# PREDETERMINATION SETTLEMENT AGREEMENT

CP# 09-19-73969  
HUD# 07-19-2744-8

According to the Certificates of Occupancy, Brick Towne Johnston (“Brick Towne”) consists of three buildings located at 6430, 6450, and 6460 Merle Hay Road. Two of the buildings are residential-unit buildings – Buildings 6430 and 6460 – each of which has 72 units housed on three stories with 24 units per story. The third building – Building 6450 – is a commercial building, which houses the leasing office, the clubhouse, and the Model Unit.

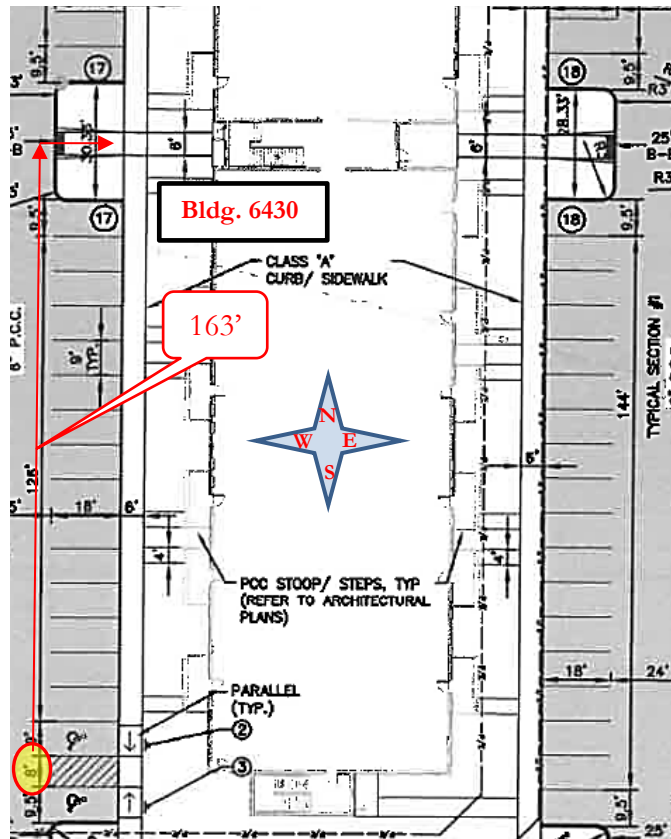
2) ICRC Investigators observed the signage at the parking space located north of the access aisle near the southwestern corner of Building 6430 only includes the “VAN ACCESSIBLE” sign and is missing the International Symbol of Accessibility required in Section 703.7.2.1 of the 2010 ADAAG.<sup>6</sup>

Based on these diagrams, the plans required the installation of a sign with the International Symbol of Accessibility at every parking space to be designated as reserved for use by persons with disabilities. However, as installed, the signage at the parking space previously described is missing the sign with International Symbol of Accessibility as required in the 2010 ADAAG. The missing signage presents a visual challenge for persons with disabilities to locate the parking space intended to be reserved for them, and may potentially result in misuse of these parking spaces by persons without disabilities.

The ICRC Investigators measured the height to the bottom edge of the sign at the parking space described above at 41 1/2” and at 54” for the sign at parking space south of the access aisle that is adjacent to the east of the Clubhouse building – which is less than the 60”-minimum height required in Section 502.6 from the ADAAG.<sup>8</sup>

No indication was found in the plans of the required minimum height to the bottom edge of signage designating parking spaces as reserved for use by persons with disabilities. The signage at both parking spaces was installed too low – making the spaces more challenging to locate by persons with disabilities.

- 1) Respondents will coordinate with the Johnston Postmaster to retrofit the mailboxes reported on page 3 of the current agreement such that the height to the midline of the keyhole of the mailbox compartments does not exceed 54”-maximum height for those compartments assigned to ground floor units.
- 2) Respondents will replace the signage at the parking adjacent to the north of the access aisle near the southwestern corner of Building 6430 and install it at a height of 60” as measured to the bottom edge of the signage.

- 2) ICRC agrees with Respondents’ proposal to replace the signage at the parking adjacent to the north of the access aisle near the southwestern corner of Building 6430 and install it at a height of 60” as measured to the bottom edge of the signage.

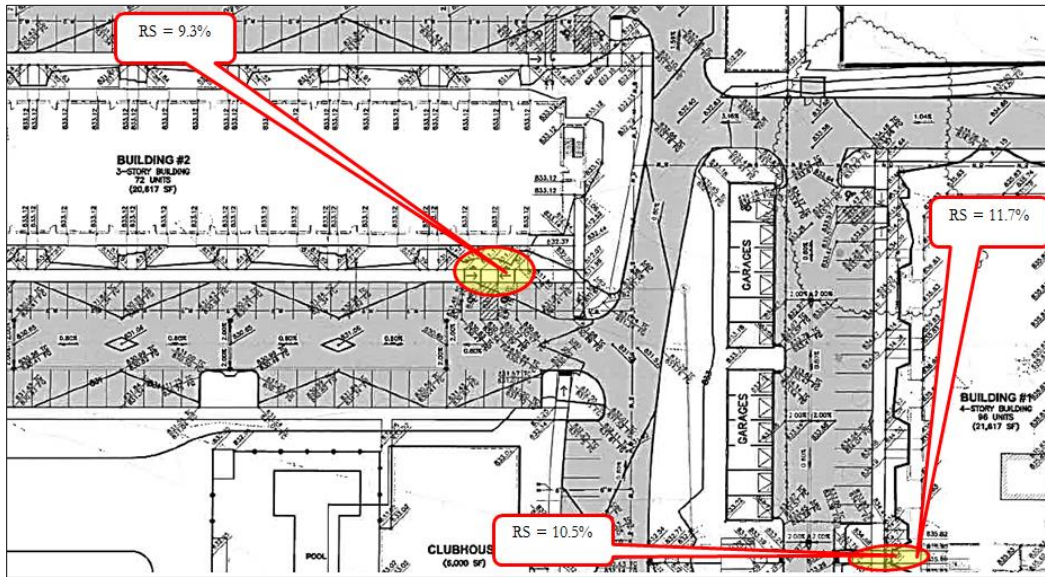
4) The ICRC investigators took several slope measurements at Brick Towne along the sidewalk paths from the access aisles to the nearest accessible building entrance. These paths need to be accessible routes because they are necessary to travel from the accessible parking spaces to the closest accessible entrance at the dwelling-unit buildings. Only those slope measurements exceeding the maximum values previously quoted are included in the following table.

The running slopes reported at the reported sections of these sidewalk paths exceed the above-referenced maximum values for running slopes of (1) the sections that are *not* curb ramps at Building 6430 – 5%-maximum running slope without handrails and the 8.33%-maximum running slope with ADA-compliant handrails; and (2) the section at Building 6460 that is a curb ramp – 8.33% maximum running slope. These paths are inaccessible to persons who utilize wheelchairs for mobility because they are too steep.

- 4) Respondents will replace the sidewalks reported on pages 6 and 7 of the current agreement with sidewalks that have slopes complying with the 5%-maximum running slope – for non-ramp sections – and 8.33%-maximum running slopes – for the ramp sections.

- 4) ICRC concurs with Respondents’ proposal to replace the sidewalks reported on pages 6 and 7 of the current agreement with sidewalks that have slopes complying with the 5%-maximum running slope – for non-ramp sections – and 8.33%-maximum slopes – for the ramp sections. If Respondents opt for installing sidewalks with values in between 5% and 8.33% at the non-ramp sections, then ICRC will require the installation of ADA-compliant handrails on both sides of those paths.

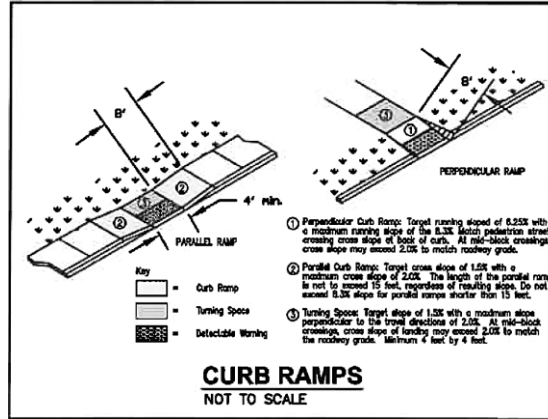
The above diagram and instructions were found to be applicable only to the sidewalk section reported for Building 6460. The reported slope value exceeds the 8.33%-maximum allowed for curb ramps. If the curb ramp at Building 6460 had been installed according to the above instructions from the plans, it would have been compliant. However, as it was built, this curb ramp is too steep.

Diagrams or instructions were not found in the plans that indicated the maximum running slope along sidewalk sections that are not curb ramps. The running slopes reported at Building 6430 exceed the 5%-maximum without handrails and the 8.33% maximum with handrails, which makes the route from the access aisle to the building entrance inaccessible because it is too steep.

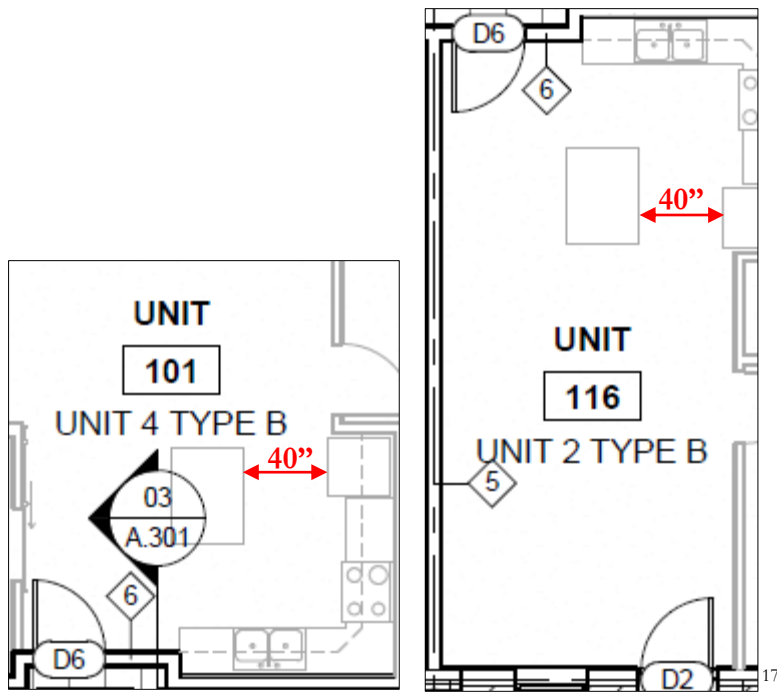
10) ICRC Investigators measured the clear width of the path between the refrigerator and opposing countertop at 35" in the kitchen of Unit 101 in Building 6460 and at 34 5/8" in the kitchen of Unit 116 in Building 6430 – which is less than the 40"-minimum required in the guidelines.<sup>16</sup>

As indicated in the scale drawings above, the clear width of the path between the refrigerator and opposing countertop was designed to be 40” in both units. If the kitchens in both units had been built as they were designed, they would have been compliant. However, as built, this path is too narrow rendering the kitchen unusable by persons who use a wheelchair.

Even though the design of the kitchen is compliant, it was designed to only meet the 40”-minimum clear width requirement, which does not allow for the typical deviation from plans – referred to as “construction tolerance” – that is commonly observed upon completion of the construction. If no allowances are made for construction tolerances during the design phase of property development, the chances of non-compliance during the final construction phase increase.

- 8) Respondents stated they moved the kitchen islands in the dwelling units to increase the clearance of the path to comply with the 40" minimum requirement and submitted two photographs in support of their claim.

8) ICRC agrees with Respondents' proposal to move the kitchen island in Unit 101 in Building 6460 and Unit 116 in Building 6430 to increase the clearance of the path to comply with the 40" minimum requirement. Respondents submitted a photograph indicating a clear width between the kitchen island and opposing features of no less than 42 5/8", which is compliant because it exceeds the 40"-minimum clear width. However, it is unknown the units where these photographs were taken at. Therefore, ICRC will require that the same retrofit indicated in the photographs submitted by Respondents to also be completed at all units where the path around the kitchen island is less than the 40"-minimum that is required by the Guidelines.

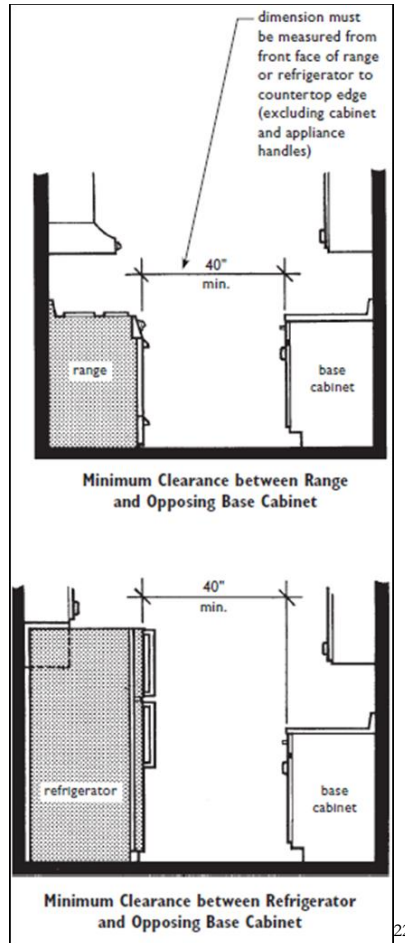
(a) The parties agree that the security keypads are directly above the grassy surface adjacent to the building entrance at all three buildings – Buildings 6430, 6450, and 6460 –which is not “stable, firm, and slip resistant,” as required by ANSI 1986.

(b) Respondents agree they will pour concrete under the security keypads – at Buildings 6430, 6450, and 6460 – to create a surface that is “stable, firm, and slip resistant,” has a slope of no more than 2% in any direction, and results in a clear floor space of no less than 30” by 48”, with the 48”-side centered on the vertical midline of the security keypad
